Access Compliance Report

Public Rights-of-Way

(Curb Ramps)

Intersection ID: 12998	Main Street: E_5TH_ST	Cross Street: N_MCDOWELL_ST	Location:	N
ADA ID: E79B805CD448	Ramp Type: Perp	Initial Pass/Fail: Fail	Overall Compliance: No	Severity Score: 25

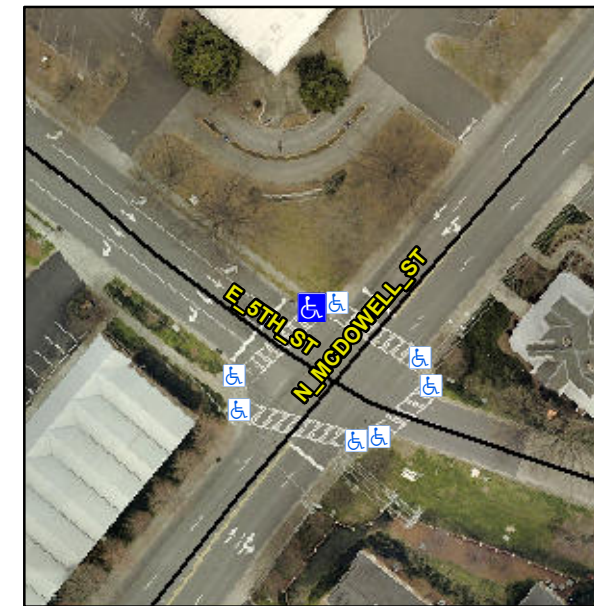
Not Found, R304.2.2, R304.5.3

Compliance	Description	Data	Compliance	Description	Data
N/A	Ramp Length (in)	84.0	No	Ramp Slope (%)	8.8
Yes	Ramp Width (in)	54.0	No	Ramp XSlope (%)	5.8
N/A	Flare Type LT	N/A	N/A	Flare Type RT	N/A
N/A	Flare Slope LT (%)	N/A	N/A	Flare Slope RT (%)	N/A
N/A	Flare Traversable LT?	N/A	N/A	Flare Traversable RT?	N/A
N/A	Landing Length (in)	N/A	N/A	DWS Provided?	N/A
N/A	Landing Width (in)	N/A	N/A	DWS Contrast?	N/A
N/A	Landing Slope (%)	N/A	N/A	DWS Length (in)	N/A
N/A	Landing X Slope (%)	N/A	N/A	DWS Full Width?	N/A
N/A	Landing Curb? (Y/N)	N/A	N/A	DWS Offset (in)	N/A
N/A	Shared Landing?	N/A			
N/A	Gutter Ponding?	N/A	N/A	Gutter Slope (%)	N/A
N/A	Gutter Lip Ht (in)	N/A	N/A	Gutter X Slope (%)	N/A
N/A	Painted X Walk1?	Yes	N/A	Painted X Walk2?	N/A
	X Walk 1 Direction	To SW		X Walk 2 Direction	N/A
N/A	X Walk 1 Width (in)	93.0	N/A	X Walk 2 Width (in)	N/A
	X Walk 1 Slope (%)	5.0		X Walk 2 Slope (%)	N/A
	X Walk 1 X Slope (%)	3.9		X Walk 2 X Slope (%)	N/A

Remove & Replace Entire Ramp.
